LIDAR Quality Report

SC_SavannahPeeDee_1_2019

2021-03-19

Based on this review, the delivered data **DOES NOT MEET** 3D Elevation Program requirements.

Figure 1

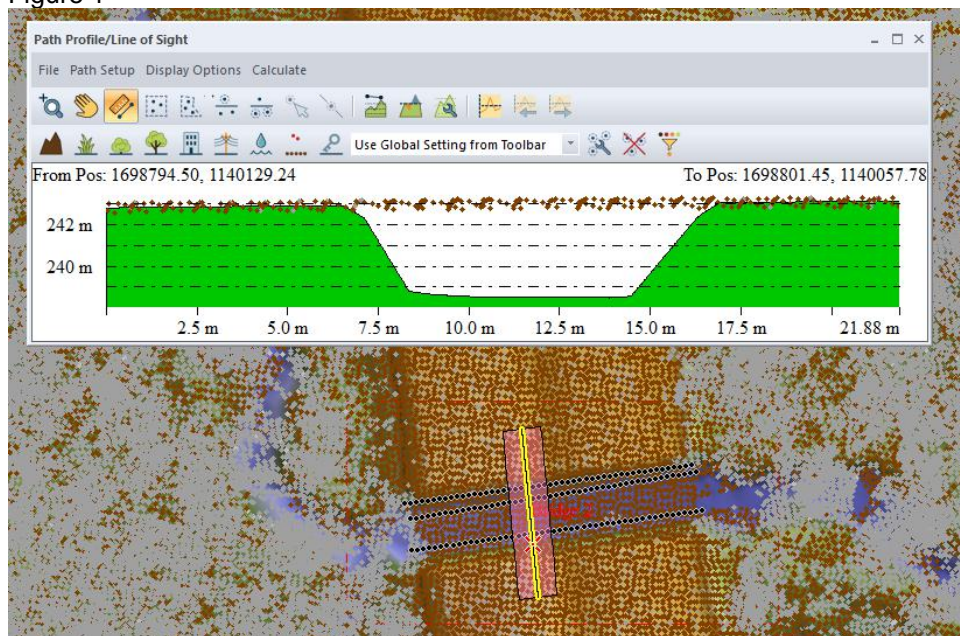
Pointcloud	Point Mis-classification	None	3	Figure 1 Figure 2 Figure 3
Error Comment(s): - 3 bridges are still classified as ground.

Error Type: Point Mis-classification, Error Subtype: None
